WELL API NO. 30-025-22201
5. Indicate Type of Lease STATE <input type="checkbox"/> FEE <input checked="" type="checkbox"/>
6. State Oil & Gas Lease No.

SUNDRY NOTICES AND REPORTS ON WELLS (DO NOT USE THIS FORM FOR PROPOSALS TO DRILL OR TO DEEPEN OR PLUG BACK TO A DIFFERENT RESERVOIR. USE "APPLICATION FOR PERMIT" (FORM C-101) FOR SUCH PROPOSALS.)		7. Lease Name or Unit Agreement Name: Humphrey Queen Unit
1. Type of Well: Oil Well <input checked="" type="checkbox"/> Gas Well <input type="checkbox"/> Other		8. Well No. 14
2. Name of Operator Prize Operating Company		9. Pool name or Wildcat Langlie Mattix, 7 Rivers-Q-Grayburg
3. Address of Operator 3500 William D. Tate, Suite 200, Grapevine, Texas 76051		
4. Well Location Unit Letter I : 2230 feet from the South line and 467 feet from the East line Section 4 Township 25S Range 37E NMPM County Lea		
10. Elevation (Show whether DR, RKB, RT, GR, etc.)

Humphrey Queen Unit #14
Plug and Abandon

"Proposed"

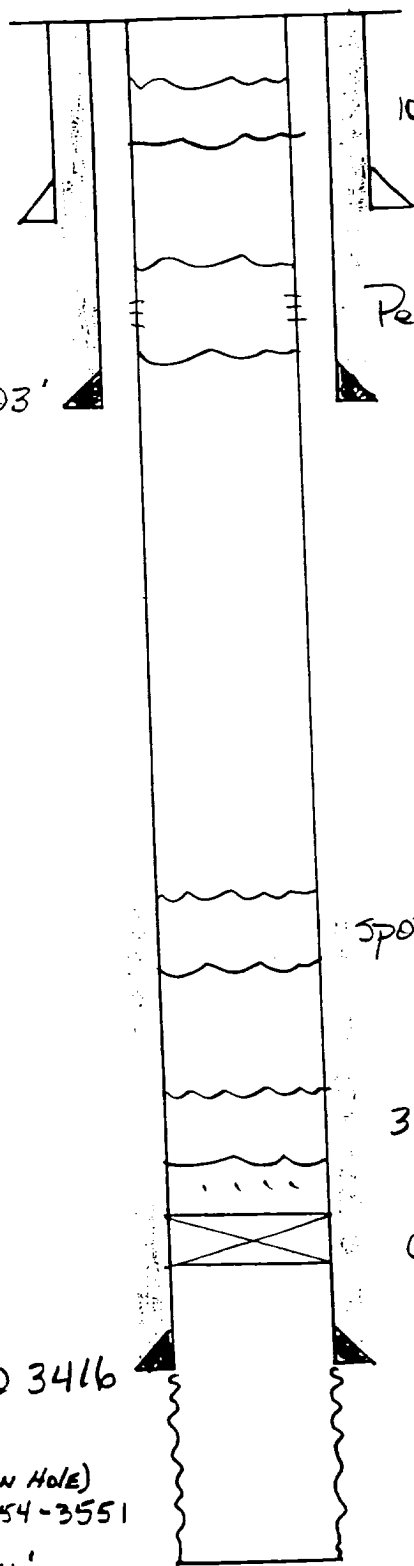
1. MIRU Workover Rig. Tag CIBP at +/- 3350'. Spot 35' of cement on top.
2. RIH with tubing and tag cement plug. Circulate hole with 10 # Brine And gel.
3. ~~Spot cement plug from 2500' - 2400'~~
PERF 1100 50' OUT IN TAG PLUG @ 1050'
4. ~~Spot cement plug from 2500' - 2400'~~
SPOT CEMENT PLUG F/ 753' - 653' - TAG
~~Perforate casing at +/- 250' and squeeze with 50 sacks cement. Spot 10 sacks surface plug.~~
5. Cut casing and cap well.
6. Set dry hole marker and clean location.

10 SX cmt surface plug

Perf. @ 250', squeeze w/ 50 SX cmt

spot cement plug from 2400' - 2500'
